MODIFICATION RECOMMENDED

E8802A-02A

S E R V I C E N O T E

E8802A PNA Microwave Network Analyzers

Figure 1: A3 Front Panel Interface Board Assy without the Bracket

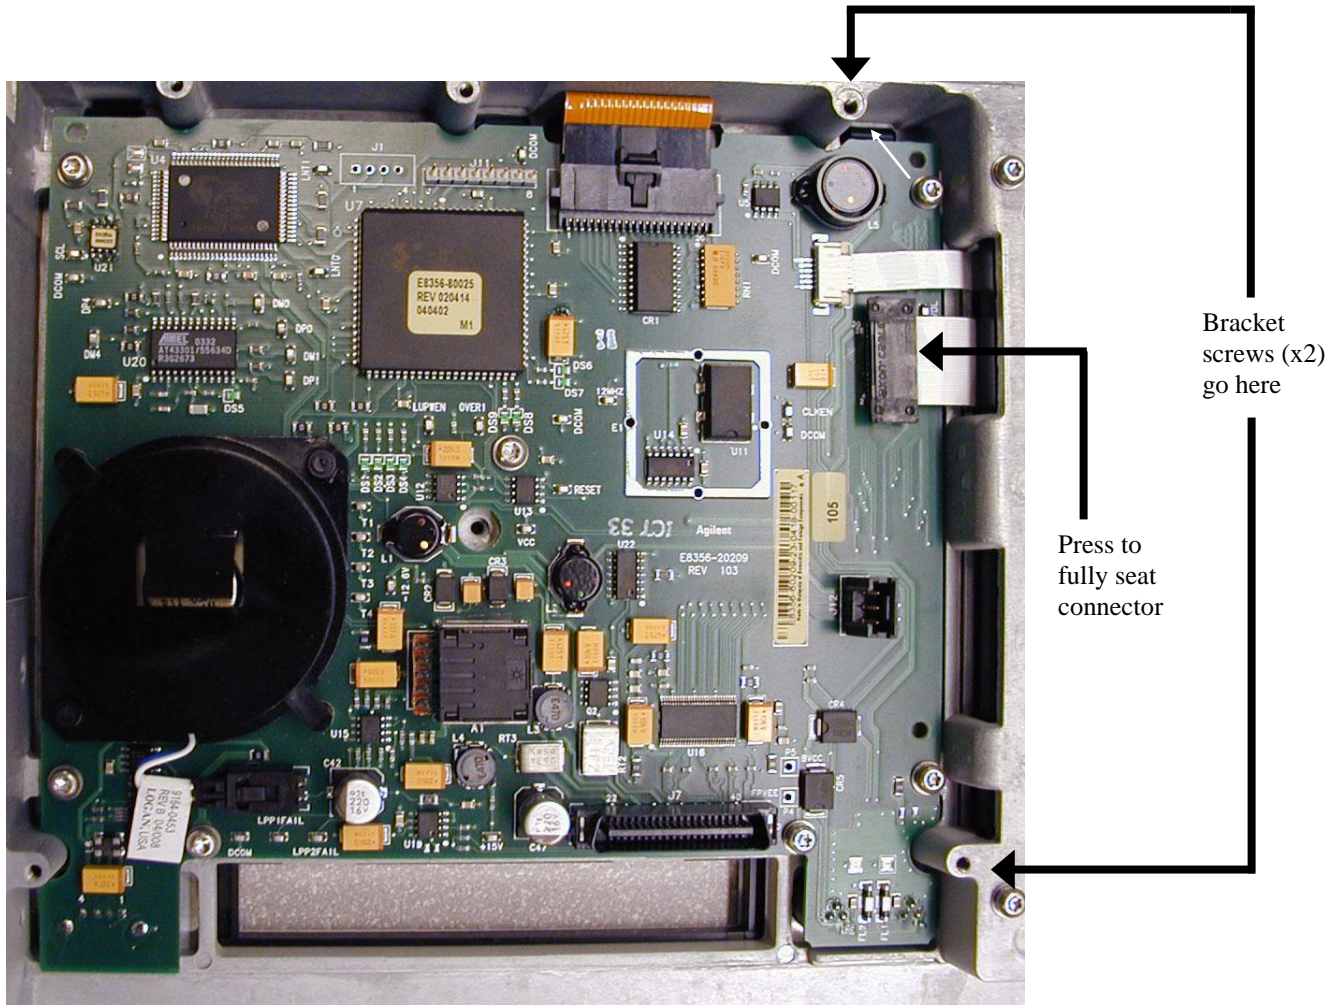
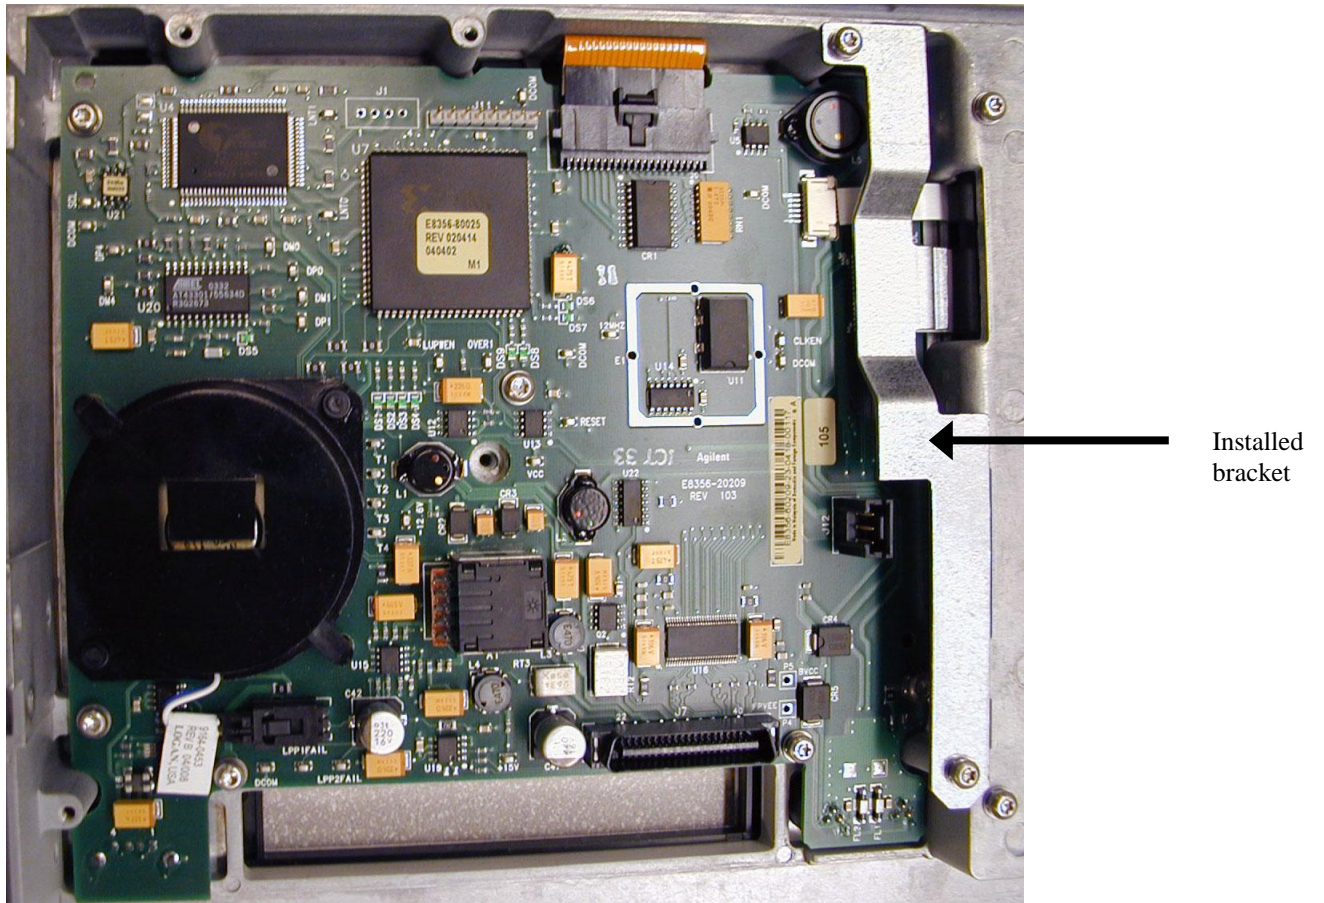
A connector of the ribbon cable (Agilent part number 8120-8409) that joins the front panel display to the front panel interface board can loosen, causing a display failure, unless a new bracket is installed. Because the failure rate has been very low, it is recommended that the bracket be installed only when there is an additional reason to remove the PNA front panel.

1. Refer to Figure 1 in this document:
 - Press down firmly on the ribbon cable's black connector.
 - Locate the two tapped holes for the bracket screws.
2. As shown in Figure 2 in this document, position the bracket so that its holes line-up with the two holes you located in the previous step.
3. Hand-start the two screws, and then torque both to 9 in-lbs.
4. Reinstall the PNA Front Panel by following the Service Guide instructions in the "Replacement Procedure." This is located on the same page as the "Removal Procedure" used previously in step 7.
